EU NCER: System Restoration Plan

Issue 43

February 2022 ~~September 2022~~ ~~December 2019~~

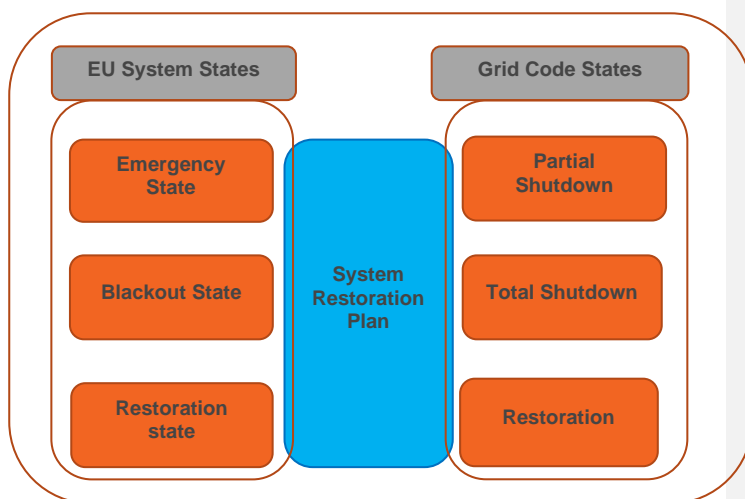
Commented [VG23]: Will this be modified as a result of the Electricity System Restoration Standard as it now includes timescales and levels of demand to be restored within these timescales? AJ Response – ESR is outside the scope of GC0148 – see above comment at top of the document.

Commented [MK24]: And DRES? AJ Response – Yes agreed – included in drafting –
